DRAWN BY: O.E. WATTS  
DATE: 1-20-20  
DWG. NO.: 19-5348-05  
SURVEYED BY: DEW, ESW, 6-26-19

PROJECT  
10634 & 10658 MALTESE POINT  
LOTS 2 & 3, ROLLING THUNDER BUSINESS PARK  
EL PASO COUNTY

SHT. NAME  
**GRADING AND EROSION CONTROL PLAN**

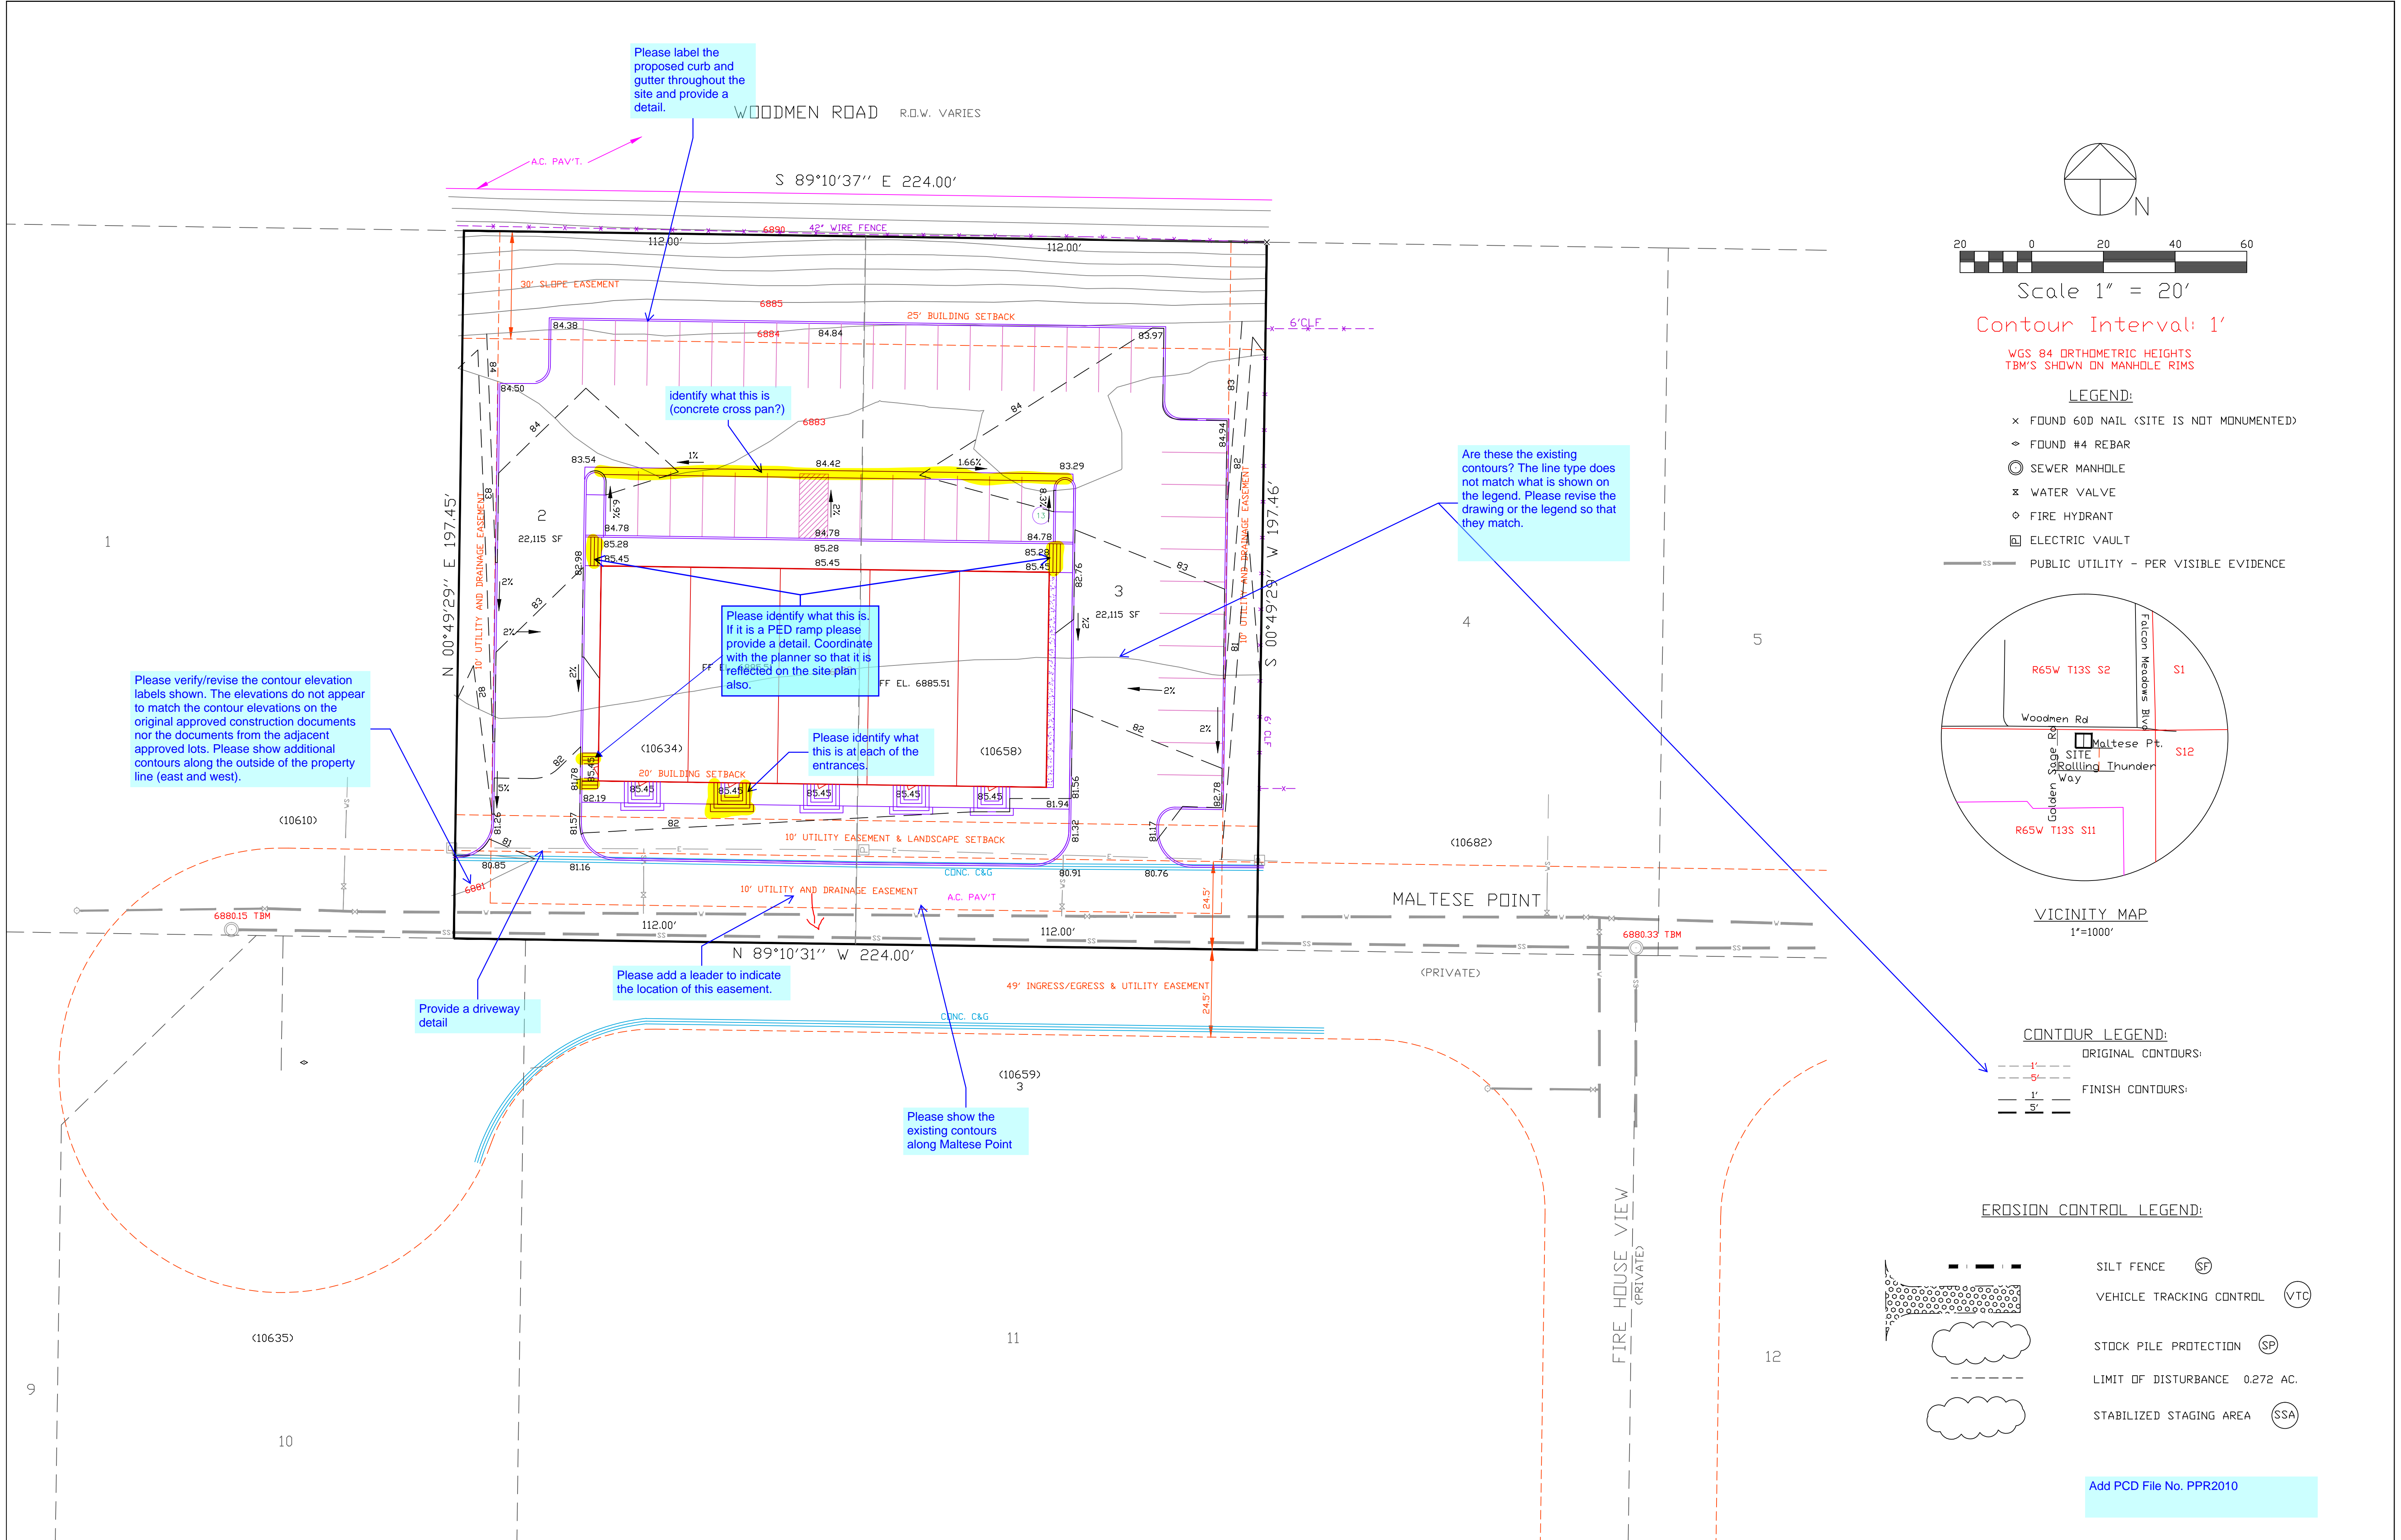
Please label the proposed curb and gutter throughout the site and provide a detail.

Add PCD File No. PPR2010

Please verify/revise the contour elevation labels shown. The elevations do not appear to match the contour elevations on the original approved construction documents nor the documents from the adjacent approved lots. Please show additional contours along the outside of the property line (east and west).

identify what this is (concrete cross pan?)

Please identify what this is. If it is a PED ramp please provide a detail. Coordinate with the planner so that it is reflected on the site plan also.

Please identify what this is at each of the entrances.

Are these the existing contours? The line type does not match what is shown on the legend. Please revise the drawing or the legend so that they match.

Provide a driveway detail

Please add a leader to indicate the location of this easement.

Please show the existing contours along Maltese Point
